U.S. NUCLEAR REGULATORY COMMISSION  
REGION IV

Docket No.: 50-458  
License No.: NPF-47  
Report No.: 50-458/97-01  
Licensee: Entergy Operations, Inc.  
Facility: River Bend Station  
Location: 5485 U.S. Highway 61  
St. Francisville, Louisiana  
Dates: January 27 through February 14, 1997  
Inspector: T. O. McKernon, Chief Examiner  
Approved By: J. L. Pellet, Chief, Operations Branch  
Division of Reactor Safety

### River Bend Station NRC Inspection Report 50-458/97-01

### NRC Post-Examination Comment Review

## RECIRCULATION PUMP SEAL FLOWS

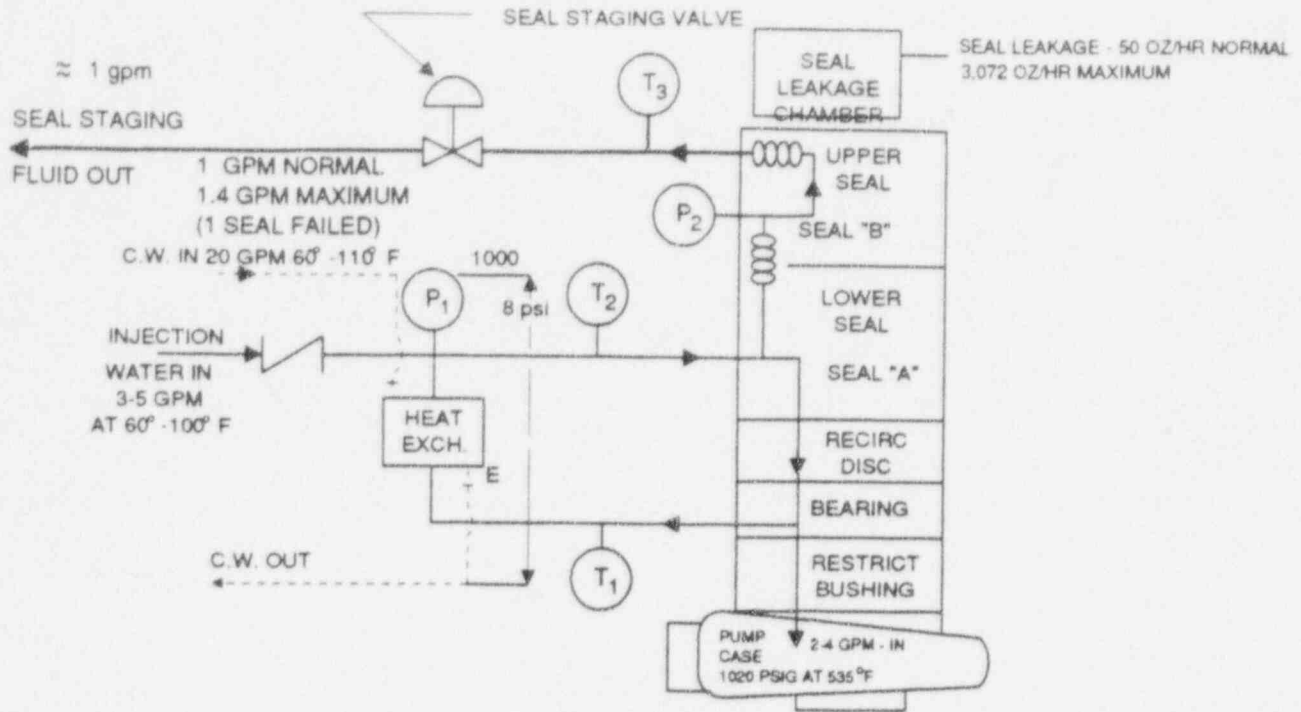
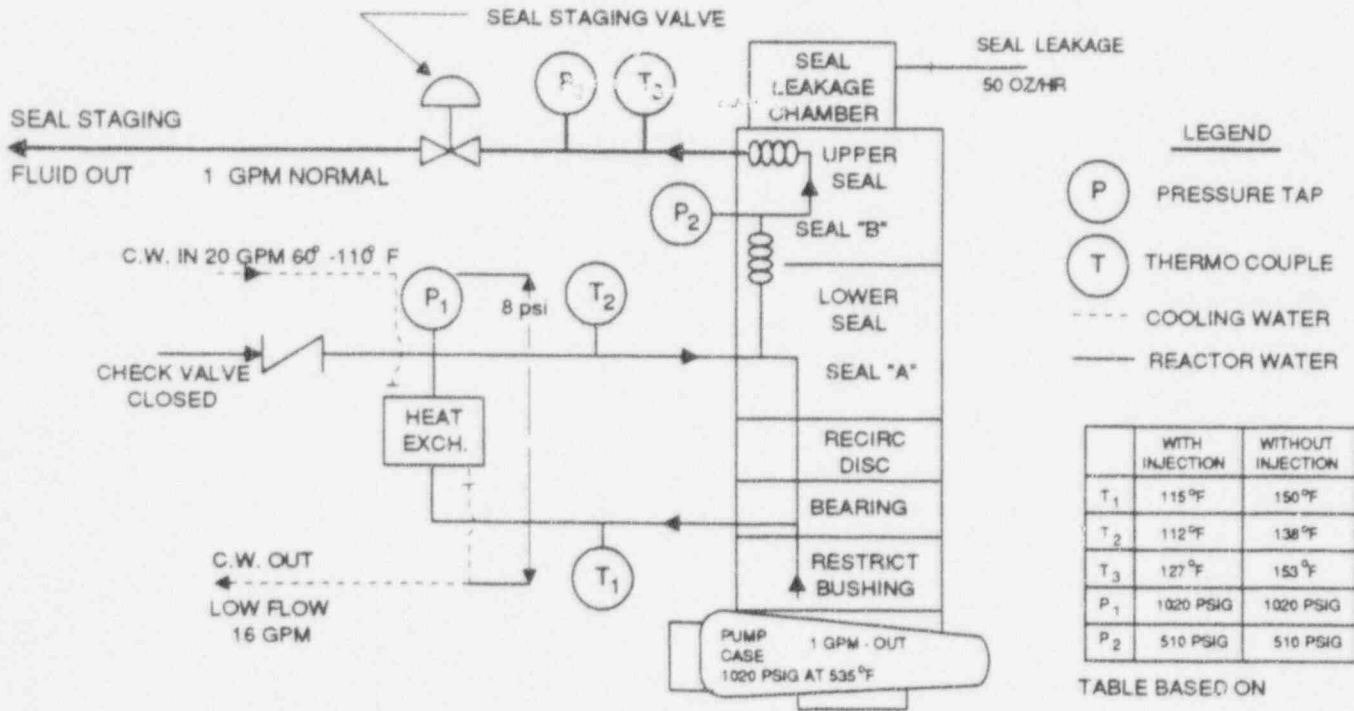
Question 46	Key Answer / Comments	Recommendations
<p>Which of the following is indication that a failure of both seals on one recirculation pump have occurred?</p> <ul style="list-style-type: none"> <li>a. Drywell identified leakage will decrease and unidentified leakage will increase.</li> <li>b. Drywell identified leakage will increase and unidentified leakage will increase.</li> <li>c. Drywell identified leakage will increase and unidentified leakage will decrease.</li> <li>d. Drywell identified leakage will decrease and unidentified leakage will decrease.</li> </ul>	<p><b>Answer:</b> b</p> <p><b>Reference:</b> STM-A0053.01</p> <p><b>Comments:</b></p> <p>Response (a) could also be correct. The amount of leakage (where and how detected) depends on the location and severity of the seal failures.</p> <p>Response (a) would be correct for a catastrophic failure of the outer seal with a minor failure of the inner seal. In this case, flow to the Drywell Equipment Drain Sump (identified leakage ) is reduced due to a drop in pressure between the seals caused by less resistance to flow into the Drywell atmosphere (unidentified leakage).</p> <p>Response (b) would be correct for a minor failure of the outer seal. This is due to an increase in pressure between the seals where flow to the Drywell Equipment Drain Sump (identified leakage) would increase with a corresponding increase in leakage to the Drywell atmosphere (unidentified leakage) due to the minor failure of the outer seal.</p>	<p>Accept both answers (a) and (b).</p>

Question #46; NRC agrees, accept either answer (a) or (b).
